Subject: RE: Objection Letter for DA2020/0302

Re: Notice of Proposed Development NO: 2020/0302

41 Upper Clifford Avenue Fairlight.

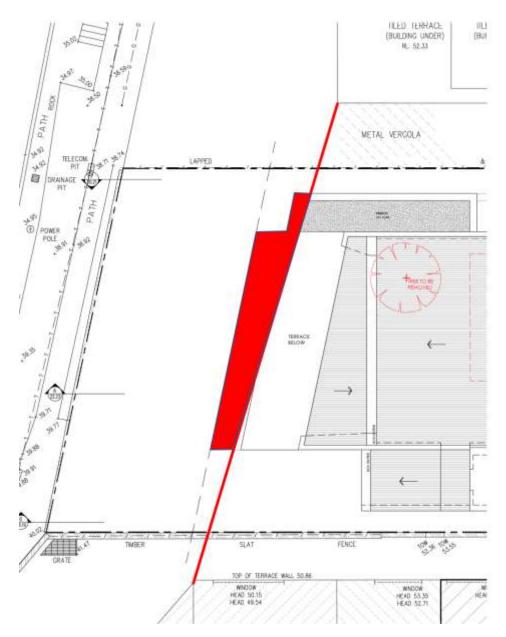
The Manly Development Control Plan (4.1.4.1) makes reference to the prevailing building line. The southern setback of 6 meters is not in line with the prevailing building which is more like 8 meters from the southern frontage on the western side of the boundary.

The below diagram shows the amount of building that extends further south to the prevailing established setback (shown by the red line between the south most corners of 43 Upper Clifford and 54 Lauderdale), and the noncompliant part of the building is shaded in red.

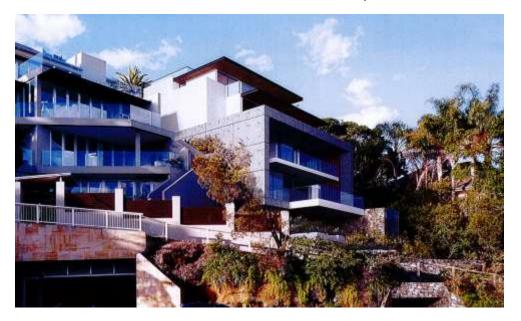
The impact to the view represented by the digital image 05 does not provide a correct sense of the view loss. I have taken a photo from approximately the same location and height as depicted and transposed the outline of the proposed building.

Clearly the impact is significant and we invite Council to our property to understand the real impact of the proposed development to our view and the corresponding degradation of our property value. In addition, erecting a template of the south western corner of the building (including balconies and upper level south western corner) would enable Council to understand the impact from other parts of our property.
